ORIGINATION FORM

Proposed Revisions to a Standard Plans Index

Index Number: 400-090
Sheet Number (s): 1
Index Title: Approach Slabs (30ft) (Flexible Pavement Approaches)

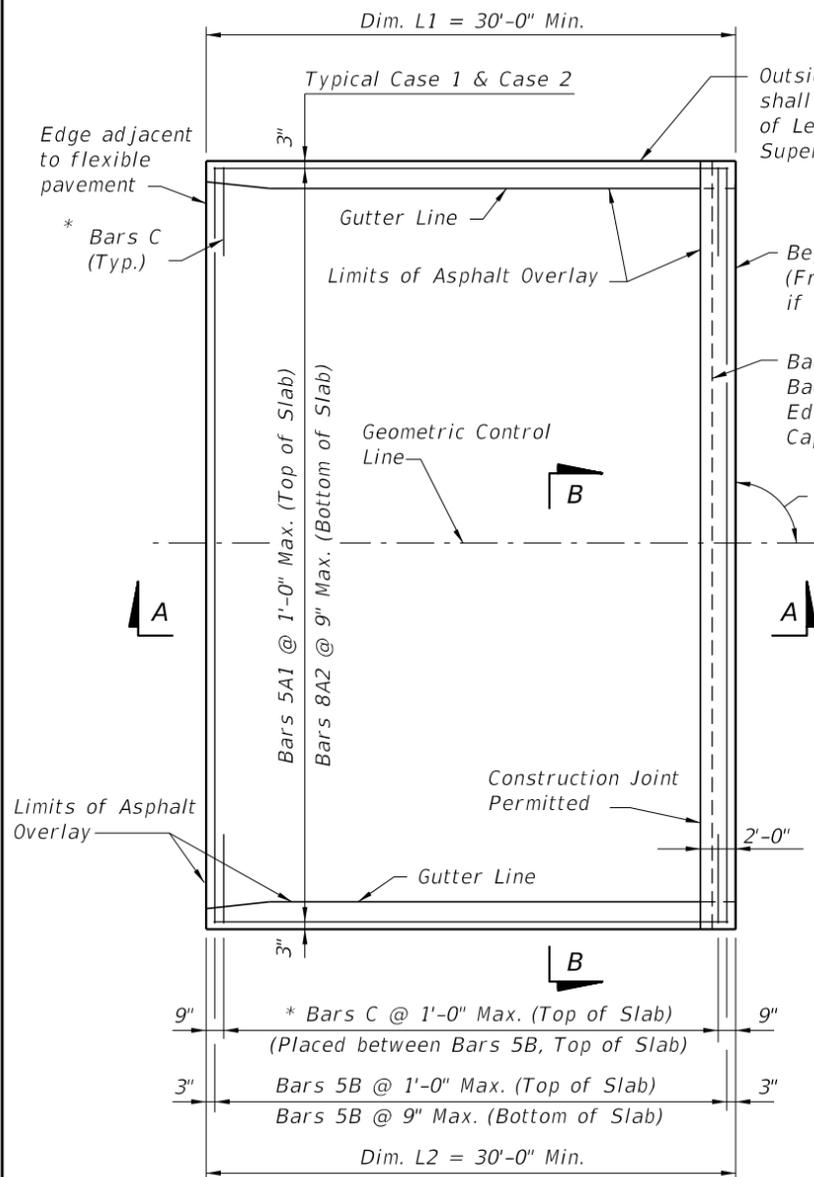
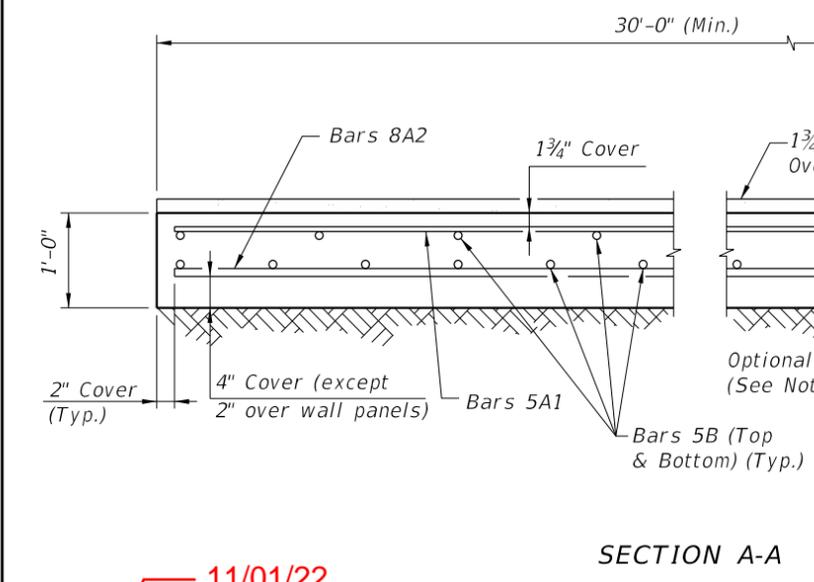
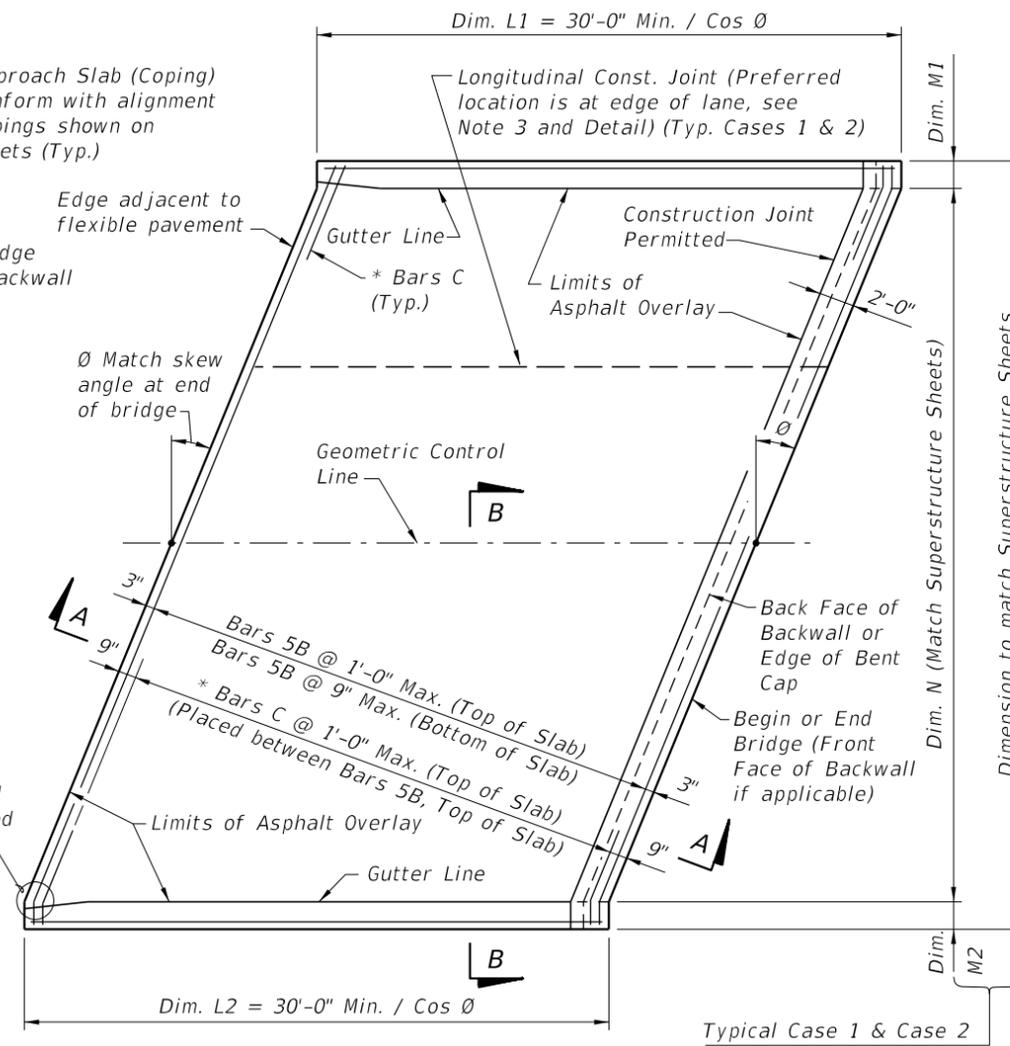
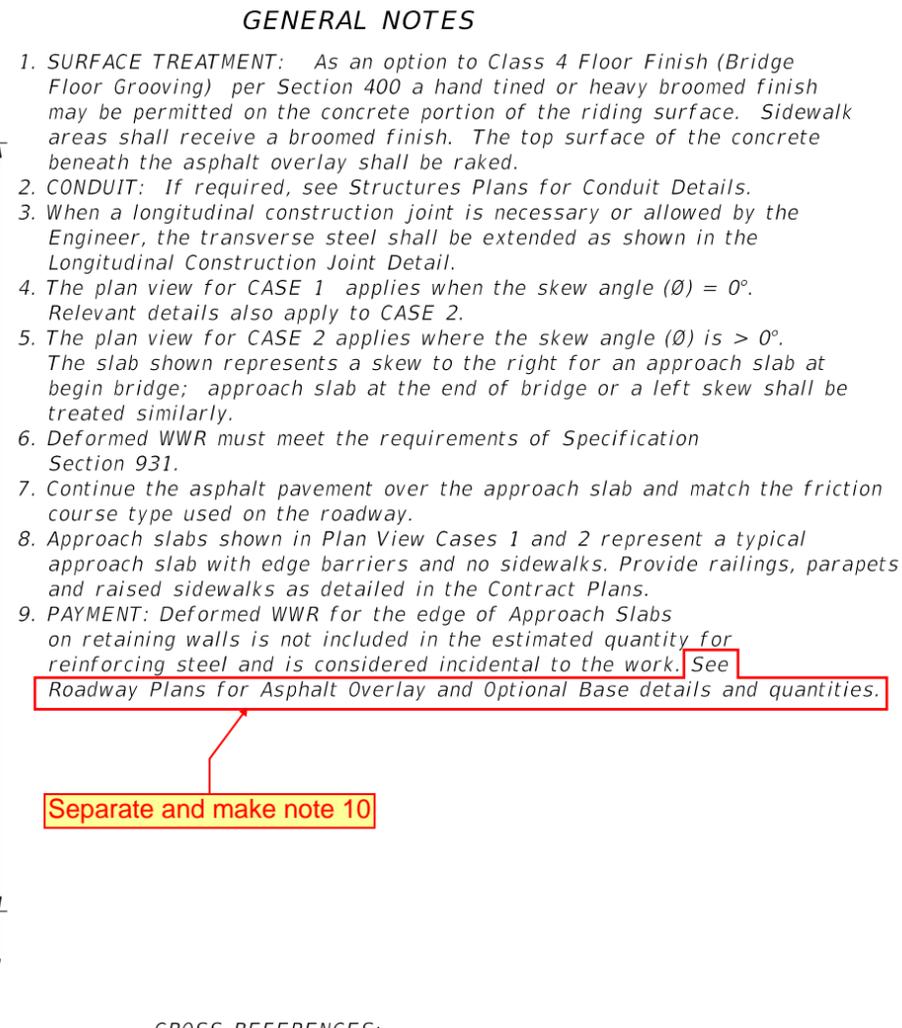
Broke note 9 into 2 notes.
